Appendix G-2:  
Geotechnical Report Addendum (2016)

October 17, 2016  
IC 16010-I

Addendum Geologic and Soils Engineering Exploration  
Geologic and Soils Engineering Exploration  
Proposed Residence and Pool  
Arb. 22, Portion of SW<sup>1</sup>/<sub>4</sub>; NE <sup>1</sup>/<sub>4</sub>; SEC 4; T1S; R14W  
3003 North Runyon Canyon Road  
Los Angeles, California

## GEOLOGY AND SOILS REPORT CORRECTION LETTER

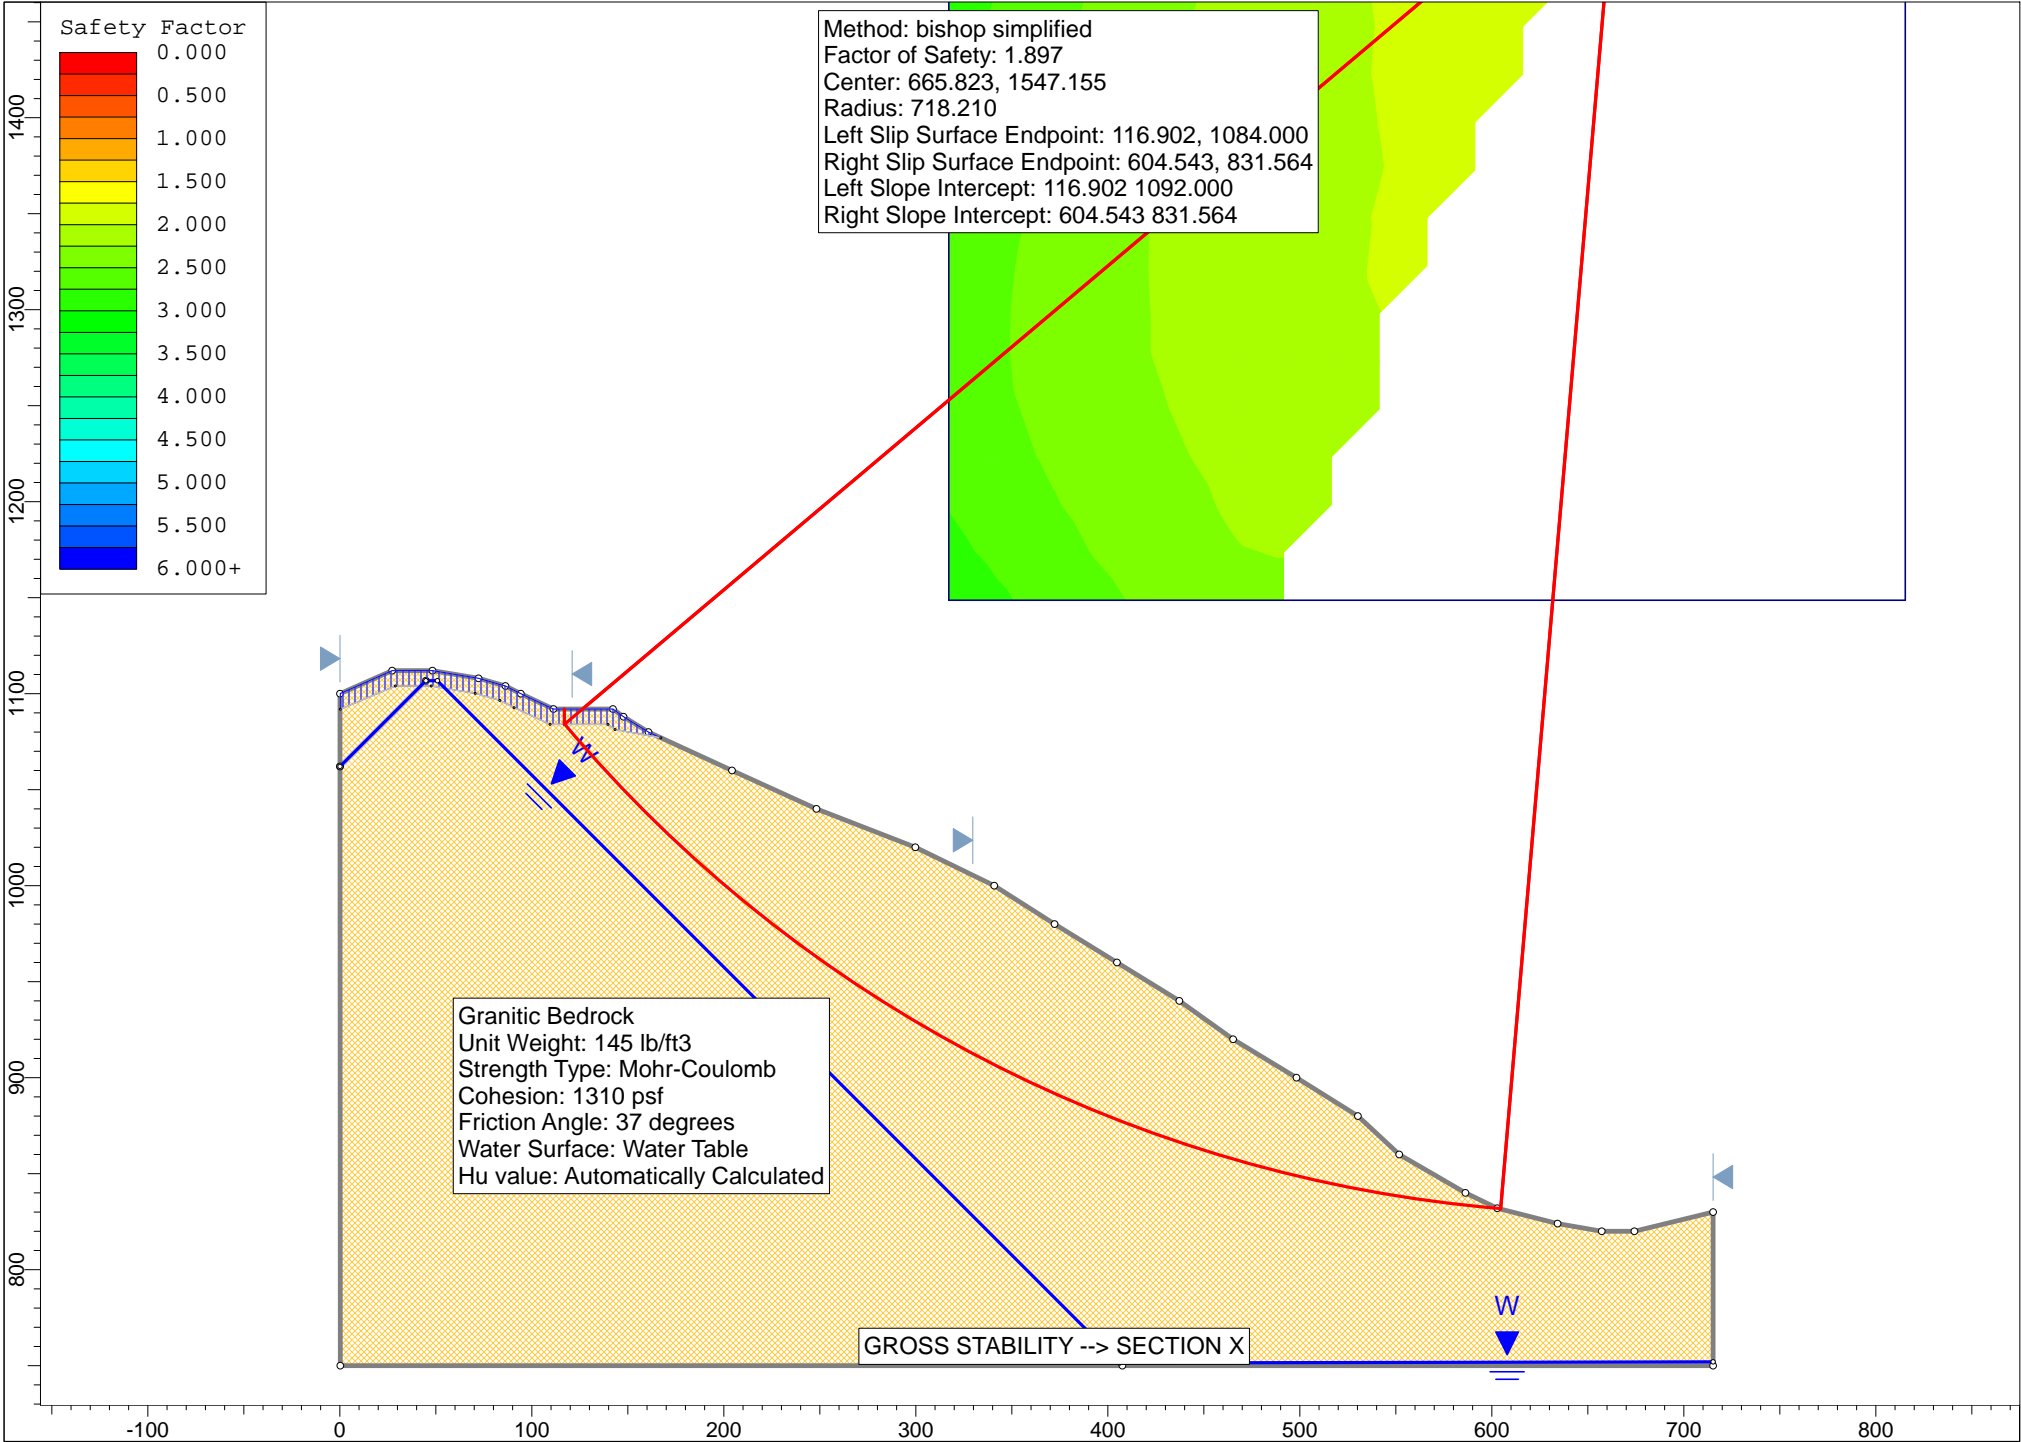
- c. Slope stability analysis of the potential failures using appropriate methods for type of failure identified from the kinematic analysis.
6. Provide a detailed sequence of excavation and implementation of construction techniques for the areas to be tunneled. Provide details of temporary support/shoring for the tunneling such as the minimum reinforcement and spacing of support columns/beams and ribbing.

Item 5c - SWEDGE was used to compute the factor of safety and shape of potential wedge failures in the direction of 200 degrees. Using a residual phi angle of 34 degrees and no cohesion, the computed safety factor for the critical wedge is 1.14. However, as shown on the graphical output page, the failure wedges are narrow and shallow.

Shallow wedge-type failures are possible for the recommended southwest-facing 1:1 trims. However, the road has been abandoned for vehicle use and is not relied upon for ingress or ingress to the residence or adjoining properties. A debris fence is recommended along the toe of the southwest-facing trim.

File Name: SectionXcalc seis  
Slide Modeler Version: 6.039  
Project Title: VALENCIA - RUNYON  
Analysis: GROSS STABILITY - SECTION X

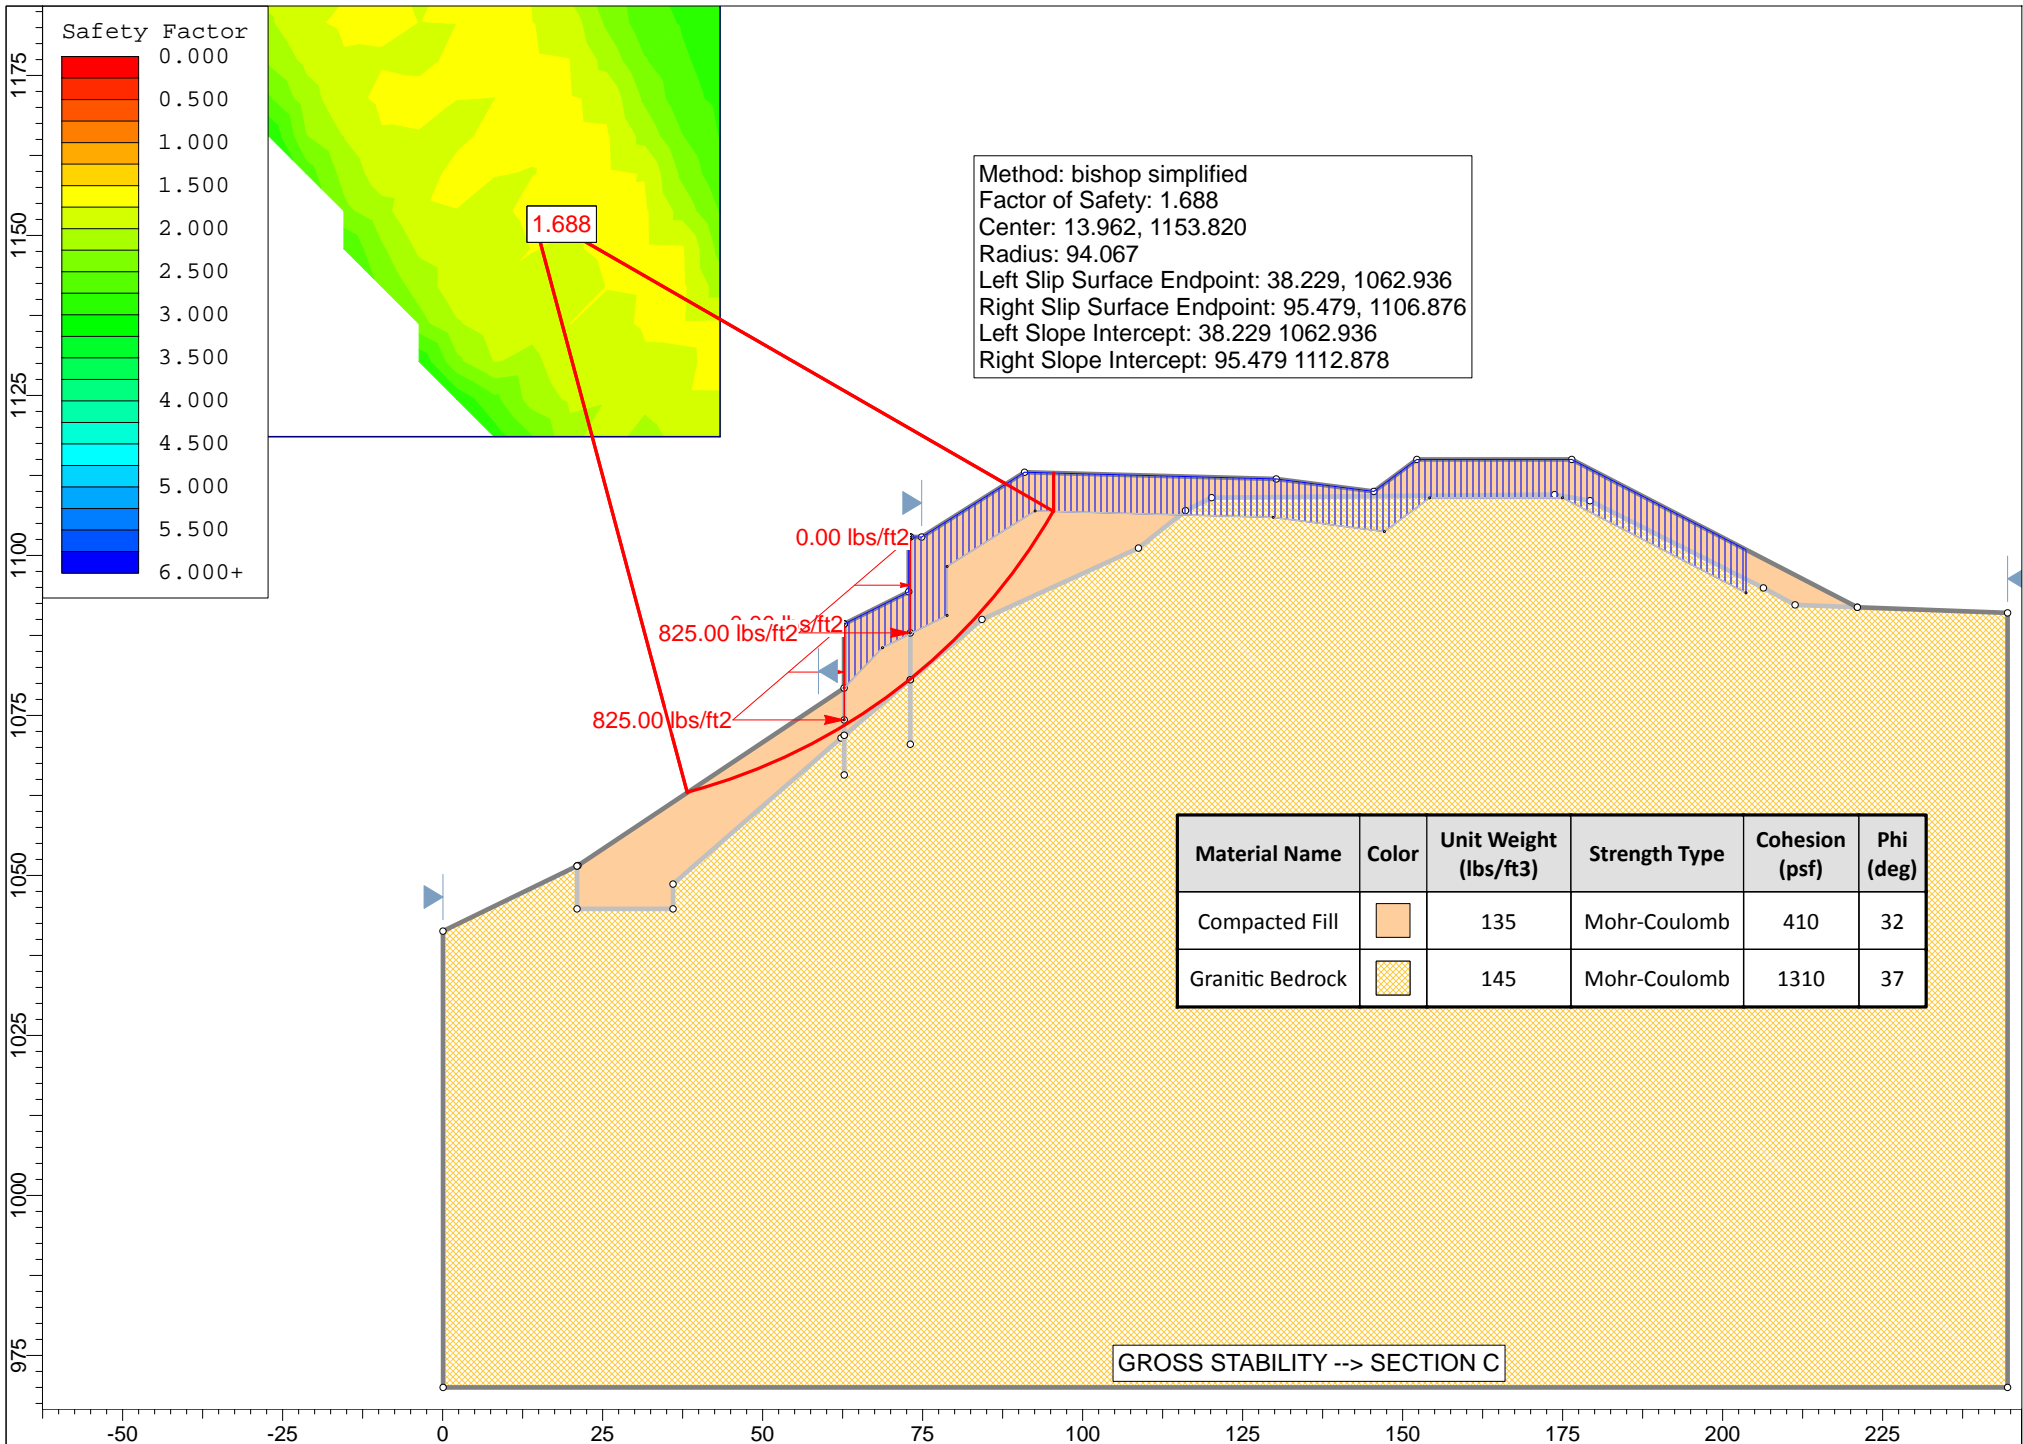
2. Provide static and seismic slope stability analyses along cross-section C based on the expected zone of saturation from the proposed seepage pits. Note: Multiple search analyses shall be utilized in the analyses, not only specified failure planes.

Item 2 - Section C was extended to the toe of slope in the canyon toward the east as new Section X. Section X is oriented to pass through the steepest slopes as shown on the Local Topo Map.

The gross stability of the slope shown in Section X was calculated using a computerized version of the Simplified Bishop's method (SLIDE Version 6.039 developed by ROCSCIENCE, Inc.). It is assumed that the effluent path will follow a 1:1 plane projected outward from the caps of the seepage pits and a groundwater surface was included in the analysis.

The seismic stability of the site was calculated in conformance with Southern California Earthquake Center (SCEC), 2002, "*Recommended Procedures for Implementation of DMG Special Publication 117*" and California Geological Survey (CGS), Special Publication 117A, 2008 "*Guidelines for Evaluating and Mitigating Seismic Hazards in California.*" Using the screening procedure and for a maximum allowable displacement of 5 cm, the horizontal acceleration ( $K_{eq}$ ) is 0.288g.

The analysis shows that the subject property and existing slopes will be grossly stable with a factor of safety in excess of 1.5 under static conditions and in excess of 1.0 under seismic conditions. The calculations use the shear tests of samples believed to represent the earth materials encountered during exploration. The cross sections and geologic structure used are the most critical for the slopes analyzed.

# SECTION B - B

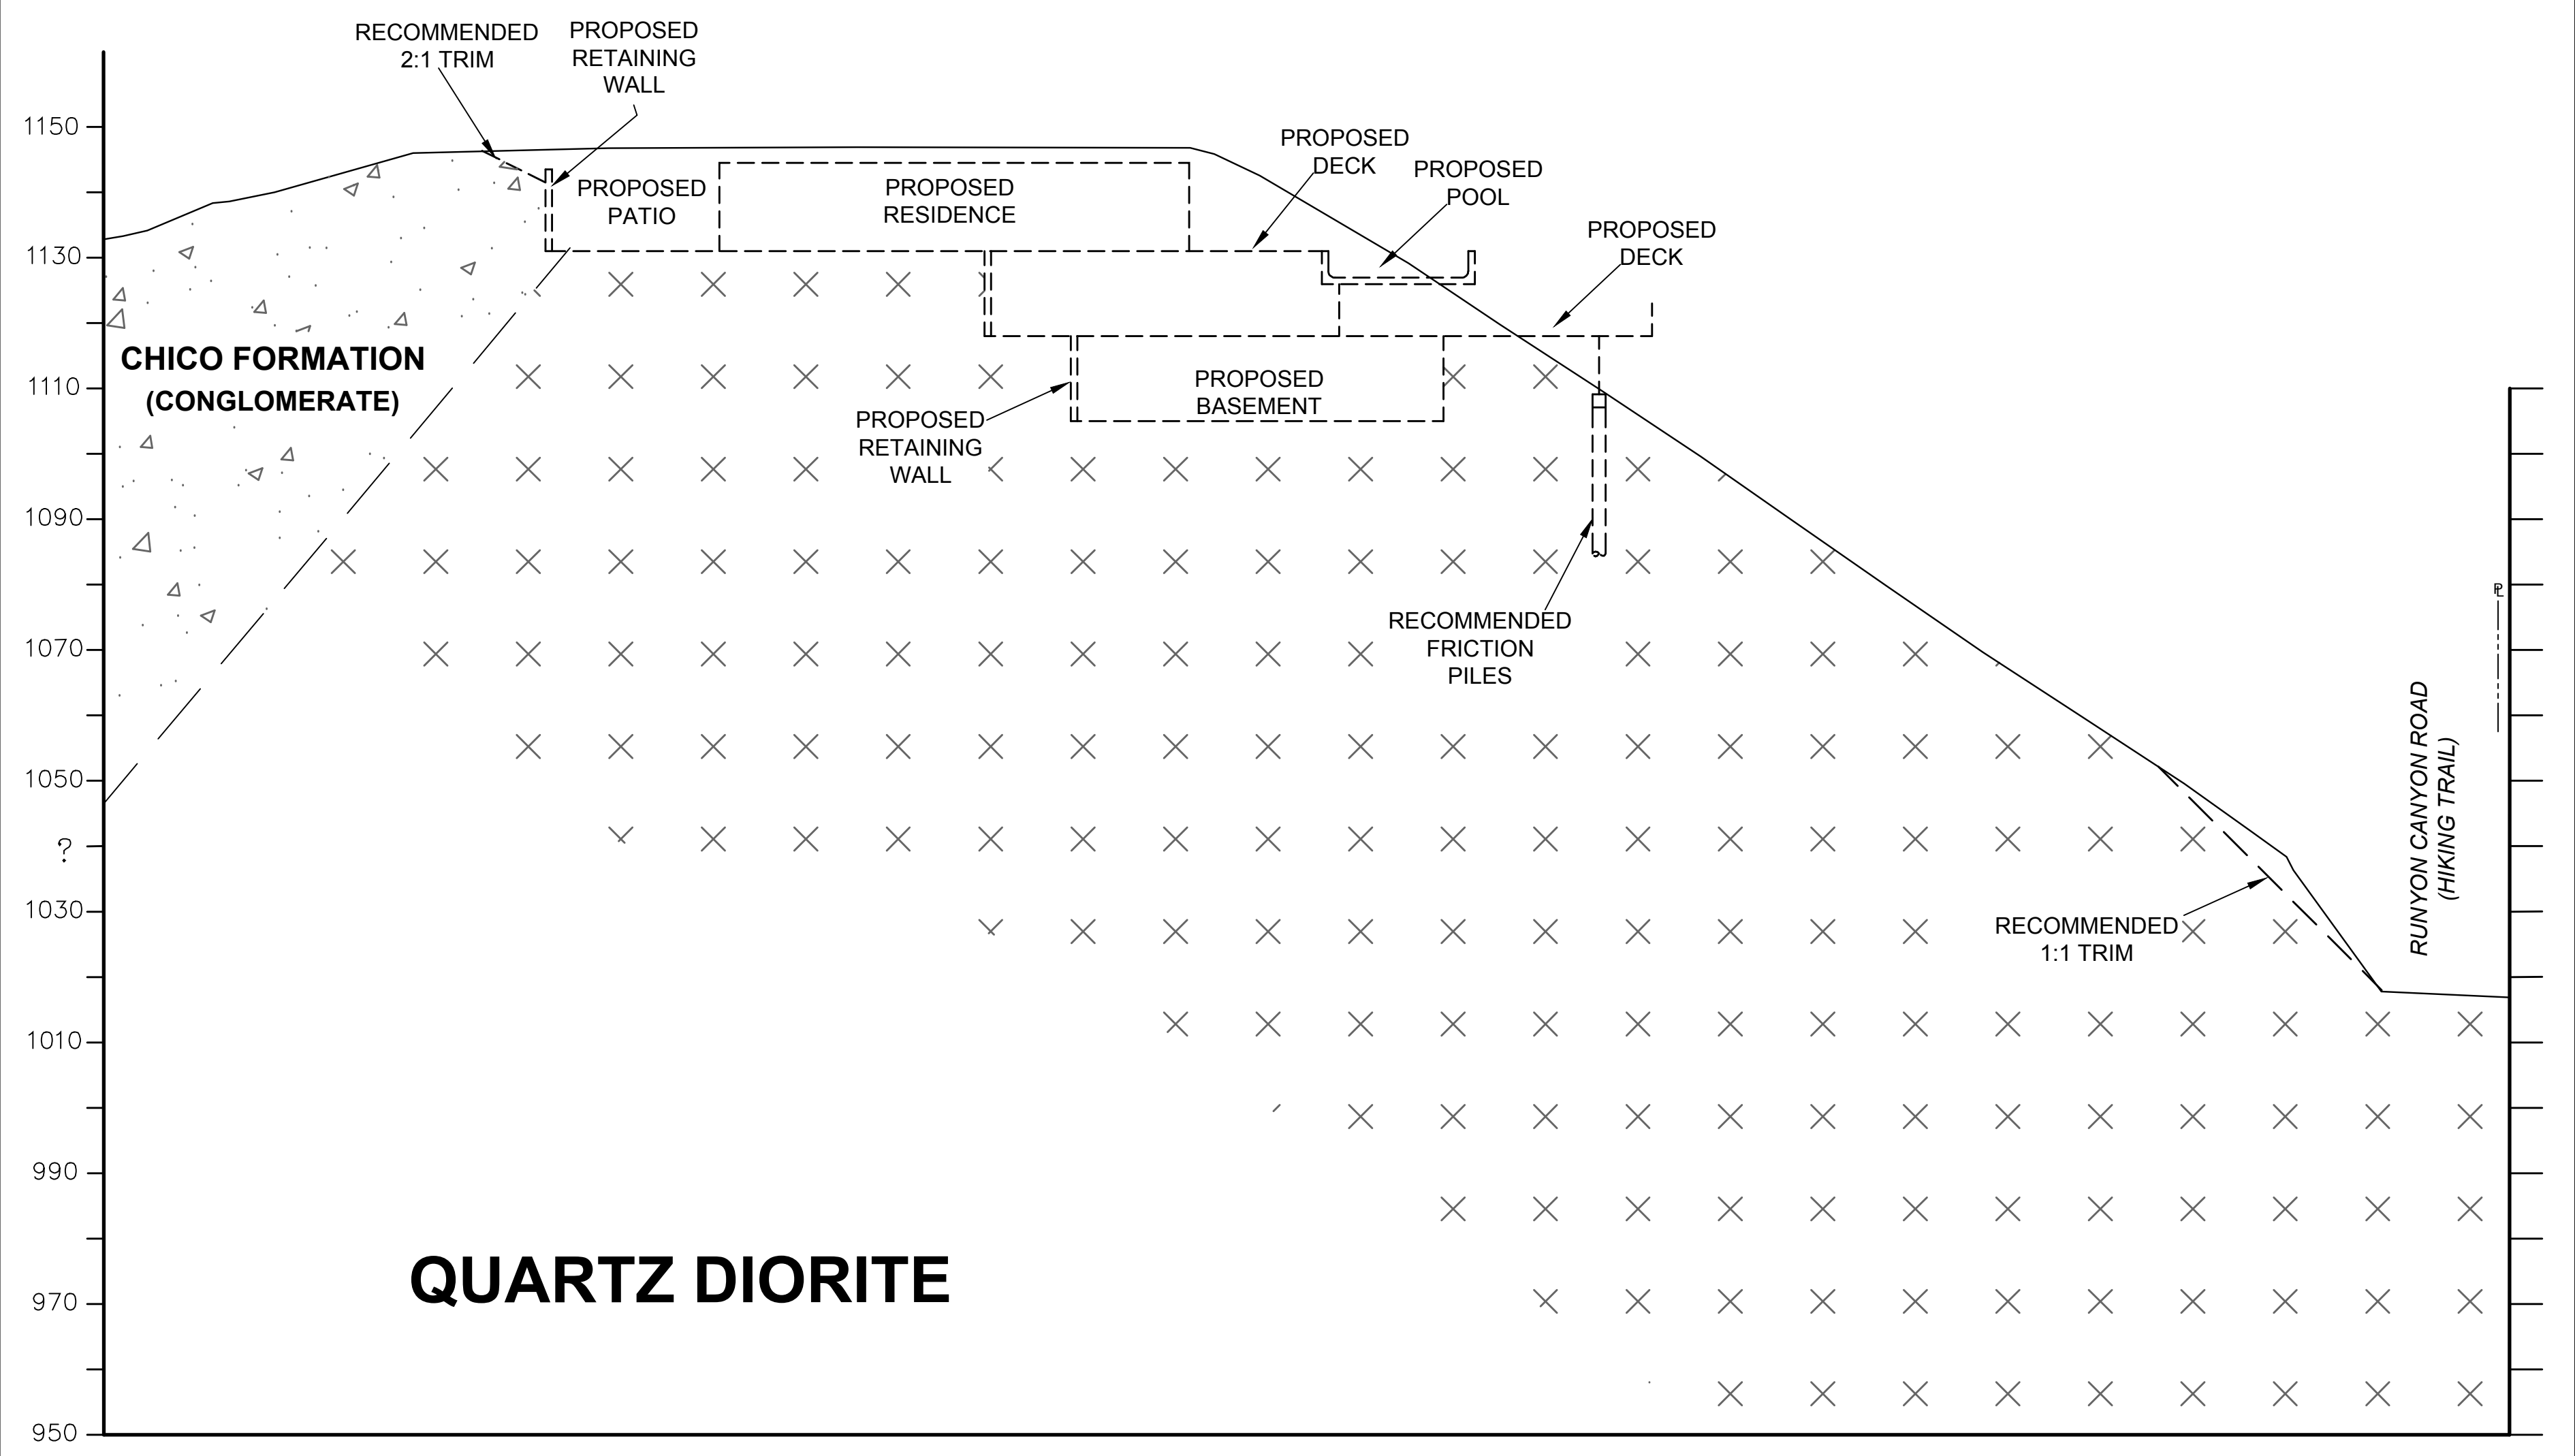
As previously recommended and shown on Section B, existing steep road cuts along Runyon canyon should be trimmed to 1:1. Labels have been added to the Geologic Map to identify areas to be trimmed.
